DEPARTMENT OF THE ARMY
US ARMY CHEMICAL SCHOOL
FORT MCCLELLAN, ALABAMA 36205- 5020

SUBJECT: REQUEST FOR ADDITIONAL INFORMATION CONCERNING
DECOMMISSIONING PLAN FOR FACILITIES UNDER LICENSE
NO. 01-02861-04.

SUBJECT: REQUEST FOR ADDITIONAL INFORMATION CONCERNING THE DECOMMISSIONING PLAN FOR THE FACILITIES COVERED UNDER LICENSE NO. 01-02861-04

AFFECTED AREA

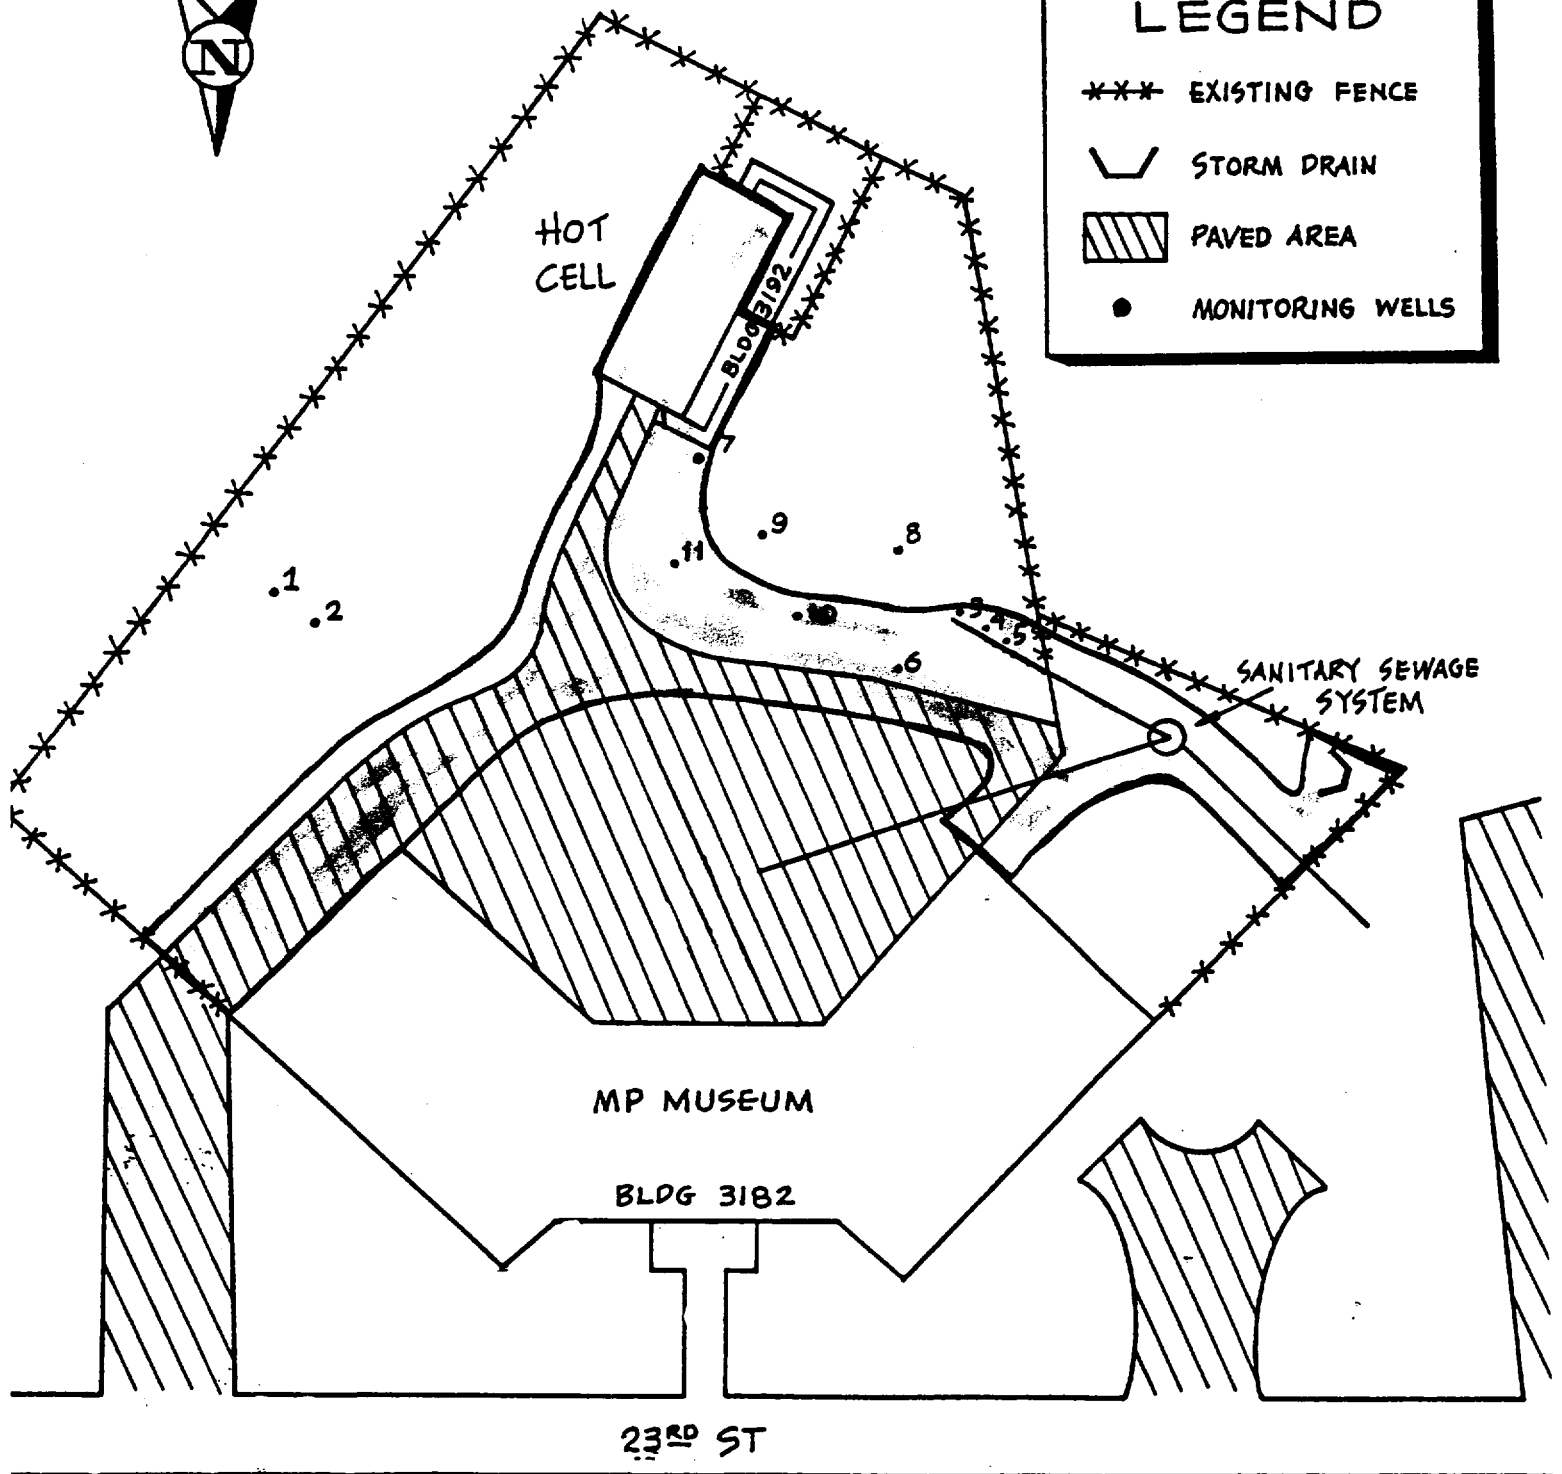
Based upon the above, and the fact that this site has been the subject of previous remediation efforts, additional information regarding the final surveys is needed. Please describe (include diagrams) those areas within and around the facility that, for the purposes of this current decommissioning effort, are considered unaffected areas versus those that are considered affected areas as defined in NUREG/CR-5849, "Manual for Conducting Radiological Surveys in Support of License Termination" (enclosure 3). Also, please confirm that the final survey will be conducted as described in NUREG/CR-5849, or provide sufficient information to demonstrate that the final survey will provide the same level of assurance that the site meets the criteria for release for unrestricted use as provided by a final survey performed in accordance with the NUREG. Please note that the results of the final survey must be reported in the same units (i.e., dpm/100 cm², pCi/g, etc.) as those associated with the applicable release criteria.

5. Response to paragraph 4. For the purpose of this remediation, affected areas will include building 3192, paved areas inside the fence not previously surveyed, unpaved areas inside the fence not previously surveyed where radioactive material was used or stored. Affected areas include shaded areas on the attached diagram. All other areas are considered unaffected areas. Unaffected areas have no history of radioactive material use or storage and are not in the migration path for contamination. Affected areas will have a final survey conducted as described in NUREG/CR-5849. (see attached)

FIGURE
SAMPLE LOCATIONS

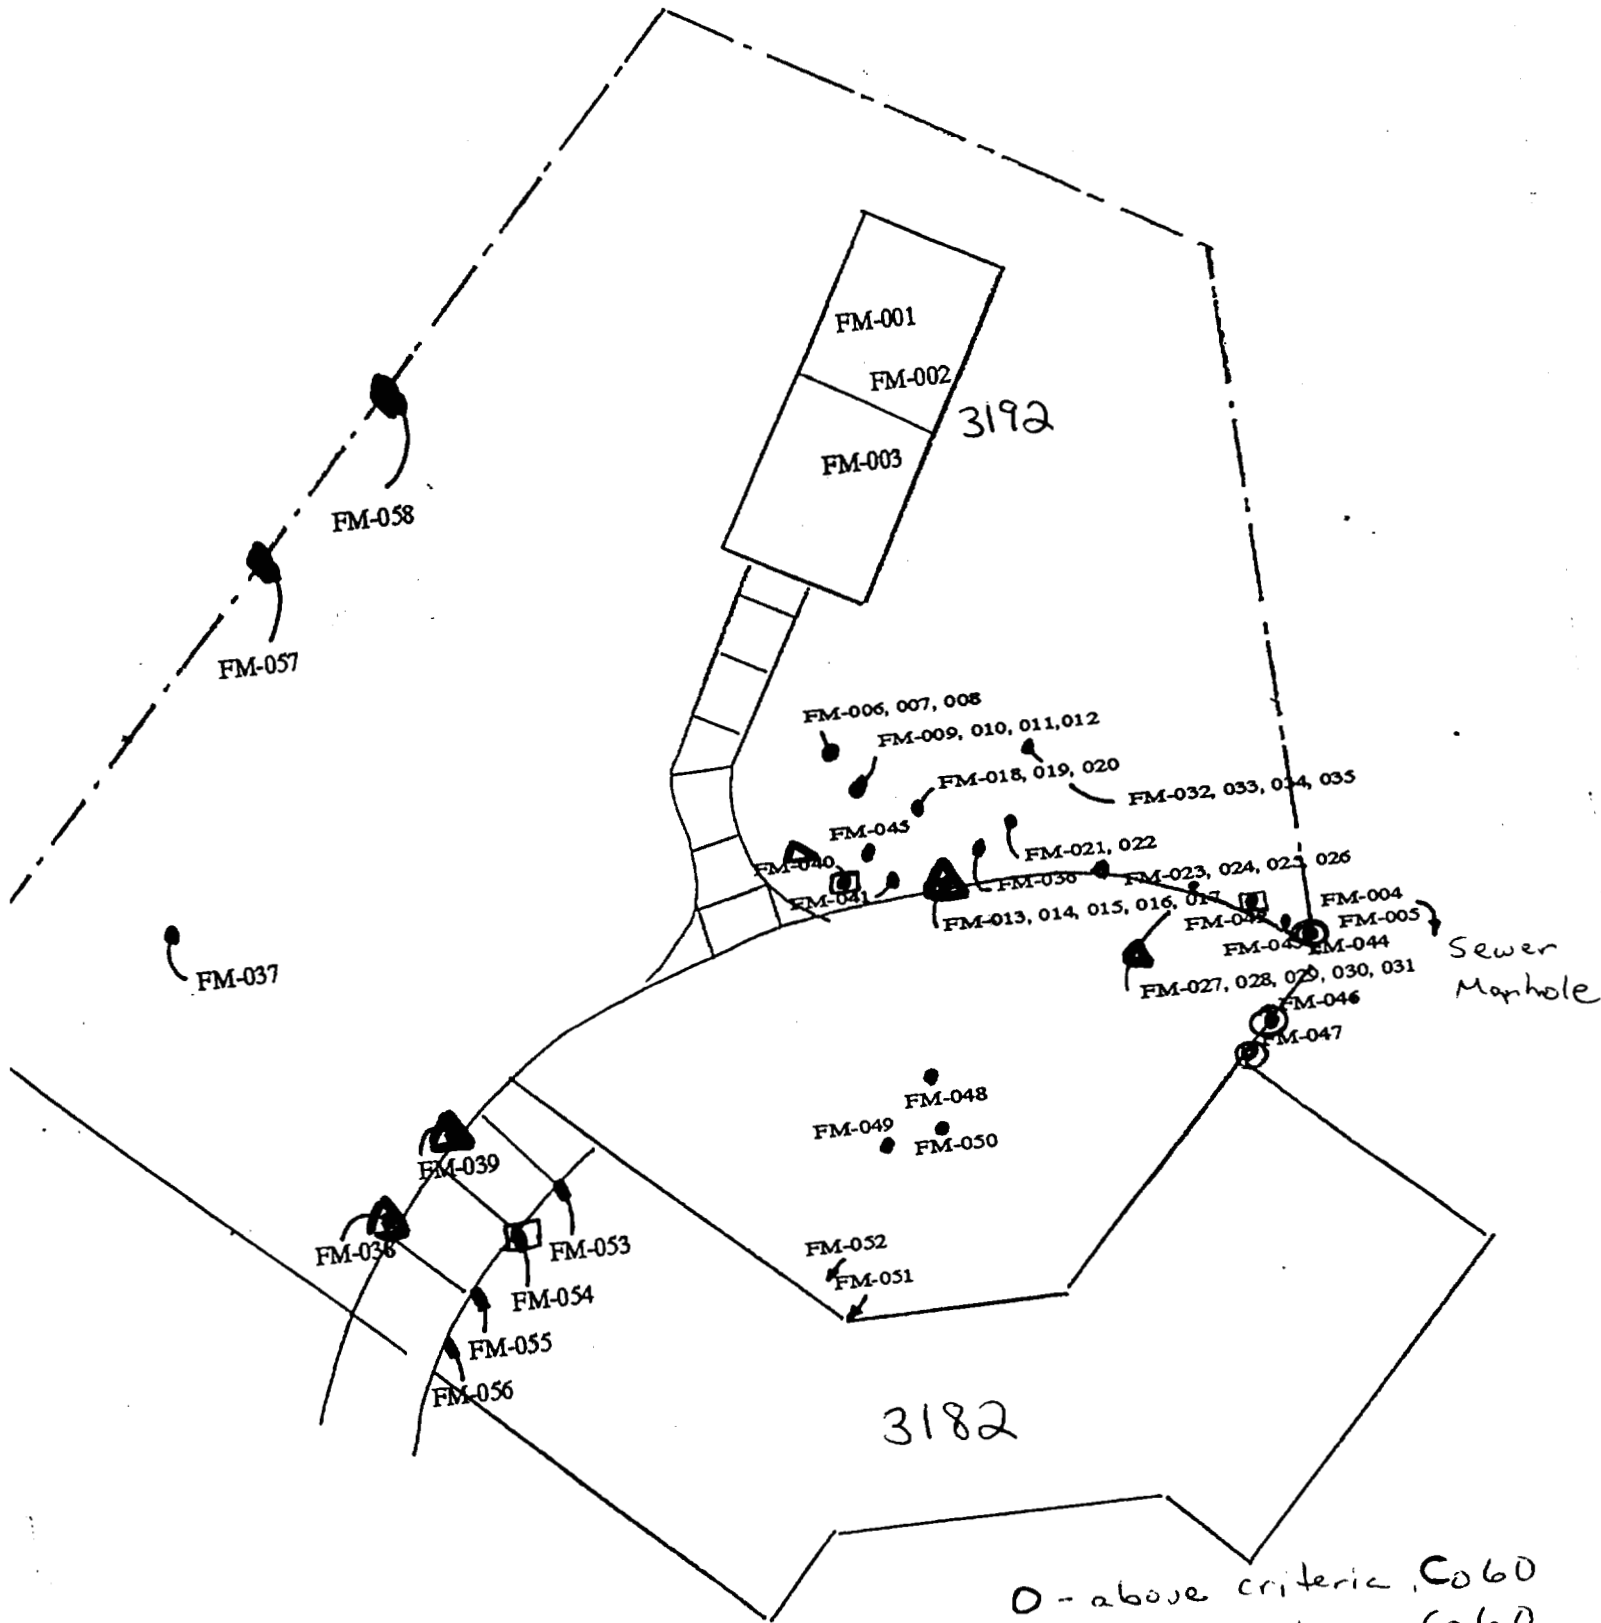
4. ATG illustrated the locations where they obtained soil samples in Figure 1 of their Sample Analysis Report dated January, 1995. Based upon their results and the sampling points as illustrated, it appears that soil contamination above NRC release criteria is present in areas near the fence perimeter at building 3182 (samples FM-043, -046 and -047) and along the sidewalk adjacent to building 3182 (samples FM-038 and -039).
